SUBJECT: NuScale Power, LLC Submittal of Changes to Tier 1 and Tier 2 of the NuScale Final Safety Analysis Report

LO-0518-60103

"Changes to NuScale Final Safety Analysis Report," public

Figure 2.3-1: Limiting Analytical Distance to ~~Site Owner Controlled Area Fence~~ EAB and LPZ Outer Boundary

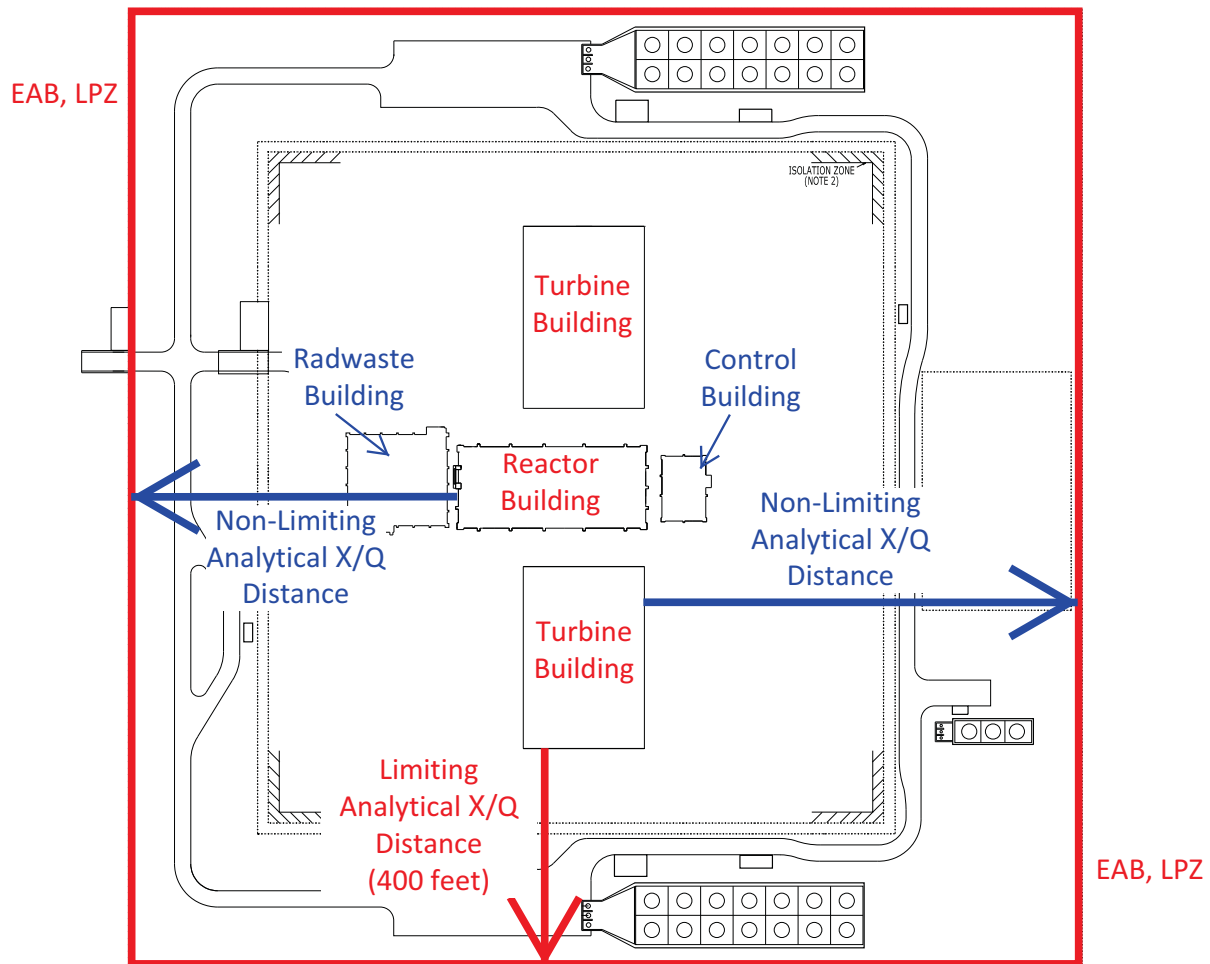
Atmospheric dispersion factors (χ/Q values) are determined at ~~the site owner controlled area boundary. This fence is as close as 400 feet from the closest release point and may be used as both~~ the exclusion area boundary (EAB) and ~~as~~ the low population zone (LPZ) outer boundary, which may be as close as 400 feet from the closest release point. These χ/Q values as well as the χ/Q values for the MCR were determined for various sites in the United States using a meteorological database that included multiple years of data across all regions of the United States. This approach determined that the meteorological dataset for Sacramento, California, between 1984-1986, is representative of the bounding 80th to 90th percentile of potential NuScale Power Plant construction sites in the United States. This meteorological data set was used to calculate the χ/Q values for the certified design.

The χ/Q values at the ~~site owner controlled area fence~~ EAB and the LPZ outer boundary are listed in Table 2.0-1. These χ/Q values are based on the source location and path shown in Figure 2.3-1.
